POWER PLANT - TRANSMITTAL OF CONTINENTAL AEROSPACE TECHNOLOGIES SIL21-04B

SEL-71-16
Page 1 of 2

SIL21-04B

SUBJECT: Improved Rocker Cover Gasket, Part No. 668893

Figure 1. Gasket Comparison

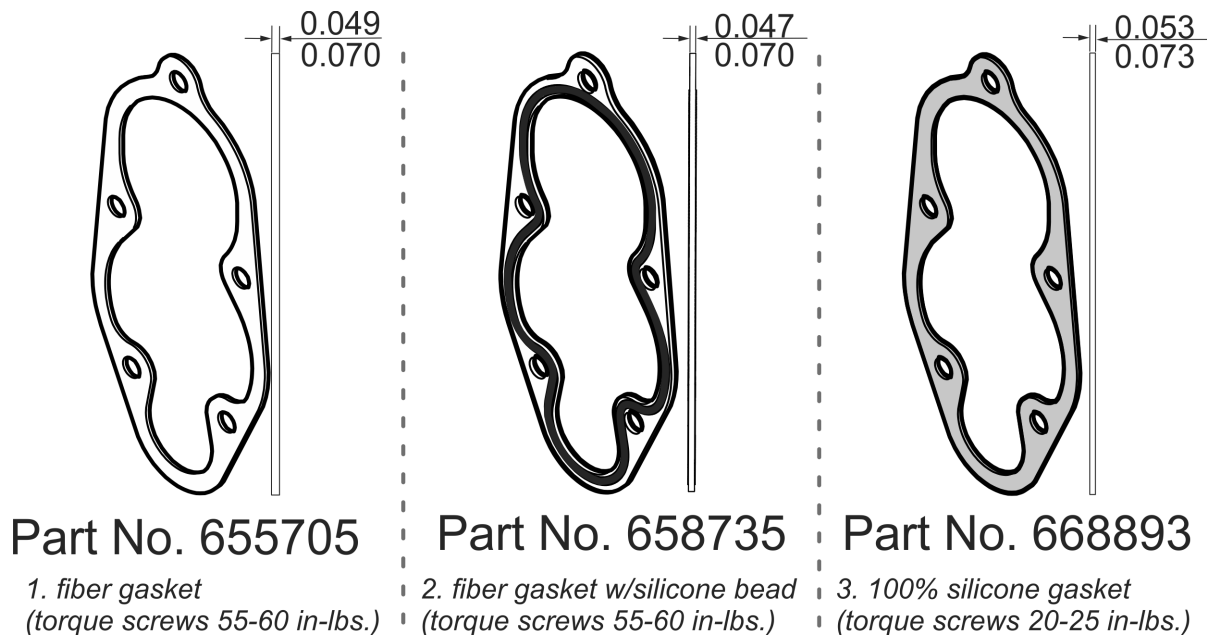
A new silicone rocker cover gasket Part No. 668893 has been placed in production for the crossflow engines listed above. Part No. 668893 gasket supersedes gasket Part No. 658735. The silicone material provides a more flexible seal than the previous gasket, when properly installed.

Rocker Cover Gasket Part No. 668893 is a flexible, silicone gasket, smooth on both sides; no special mating instructions apply. Rocker Cover Gasket Part No. 658735 is a fiber gasket with a silicone bead on both sides of the gasket. Gasket Part No. 655705 (preceded Part No. 658735) and previous gaskets used with crossflow style cylinders were fiber gaskets with no bead. Earlier gaskets were subject to age control; Part No. 668893 is not.

Figure 2. Rocker Cover Installation

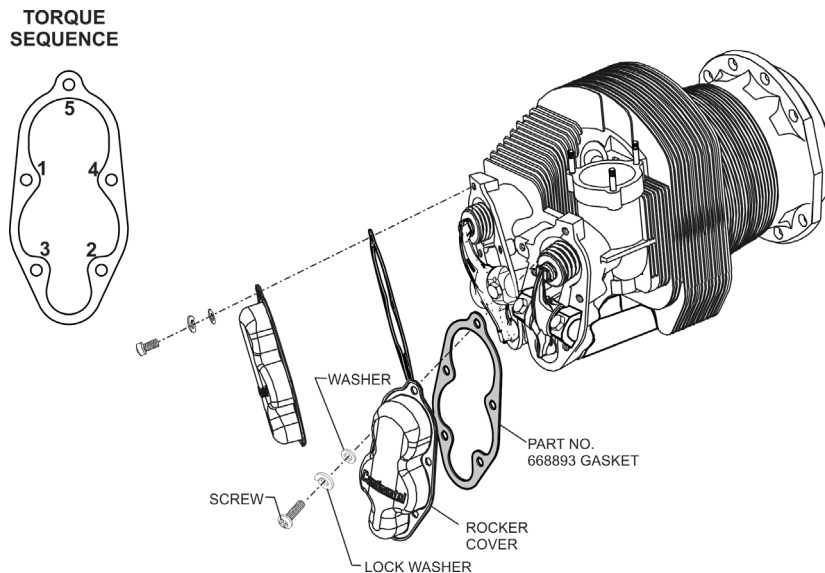
CAUTION: Failure to clean the rocker and cover flanges will cause leaks. Surfaces must be clean and oil-free to seal properly. Applying 55-65 in-lbs. torque to rocker cover fasteners using Rocker Cover Gasket Part No. 668893 will damage the gasket and rocker cover.

1. Clean the rocker box (including threaded screw holes) and cover flanges thoroughly with isopropyl alcohol (IPA) or acetone before installing the gasket to remove oil and old gasket residue. Clean the rocker cover screw threads with a wire brush and rinse with IPA or acetone.
2. Install rocker cover(s) with new gasket according to instructions in the primary ICA.
3. Sparingly apply a thin bead of Continental Part No. 658517 (Loctite® 243) across the rocker cover screw threads according to the manufacturer's instructions. Secure each rocker cover with five screws and torque the screws in an alternating pattern (see Figure 2):

- a. On rockers using gasket Part No. 668893, torque cover screws 20-25 in-lbs.
- b. On rockers using any fiber gasket, torque cover screws 55-60 in-lbs.
